Access Compliance Report Public Rights-of-Way (Curb Ramps)

Main Street: EARLHAM_ST Cross Street: E_WALNUT_AVE Location: NE

ADA ID: RPAT211020102724 Ramp Type: Type 4 - Parallel Initial Pass/Fail: Pass Overall Compliance: No Severity Score: 5

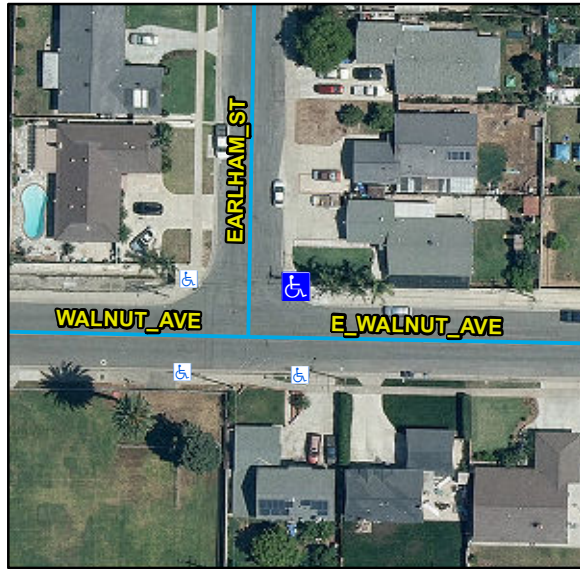
Crossing 1 Slope (%)	1.7		Crossing 2 Slope (%)	3
	Crossing 1 Cross Slope (%)	0		Crossing 2 Cross Slope (%)	1.1
Yes	Gutter Ponding	No	Yes	Curb Slope	1.5
Yes	Gutter Lip Height (in)	0		Road Run Slope (%)	0.2
No	Gutter Run Slope (%)	6.8		Road Cross Slope (%)	1.9
Yes	Gutter Cross Slope (%)	0.9	Yes	Perpendicular Joint Present	Yes
Yes	Overall Surface Condition	Acceptable			
	Cross Gutter Present?	No		Spandrel Present?	No
	Replace Cross Gutter?	N/A		Replace Spandrel?	N/A

Remove & Replace Gutter.
